Active Errata List

Rad Hard 16 MegaBit SRAM Multi-Chip Module

AT68166F/FT Errata Sheet

Figure 1. Worst case conditions: 125 °C Failure Conditions

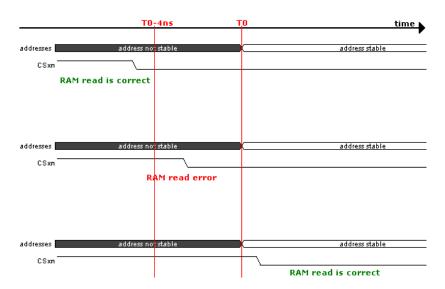
In conclusion, there may exist a very narrow window, within which, if the chip select line is asserted low and address lines change, a corruption of data Bit 5 (and Bit 6 sometimes) occurs during a RAM zero read access.

Typical window size is 0.3ns to 1ns.

- Addresses are stable at time T0.
- The RAM chip select (CSxn) is driven low in a T0 4ns / T0 timing window.

Datasheet is guaranteed out of the window described in errata-sheet for both AT68166F/FT

- As the first solution, Atmel strongly recommends the board designer to verify that best, typical and worst case conditions of the application do not lead to fall in the possible error window:
 - chip select activated (driven Low) before T0-4ns
 - chip select activated (driven Low) after T0
- For boards falling in the not functional window, Atmel recommends to add a delay on CS to be out of the window (no evolution out of the window in guaranteed life-time and radiation exposure). Delay can be done by any solution as serial resistor, serial buffer or other.
- 3. Atmel envisages giving a better TELQV value than currently specified in the datasheet (1 or 2 ns improvement depending on versions). This improvement will give more margin on CSn to escape from the error window.
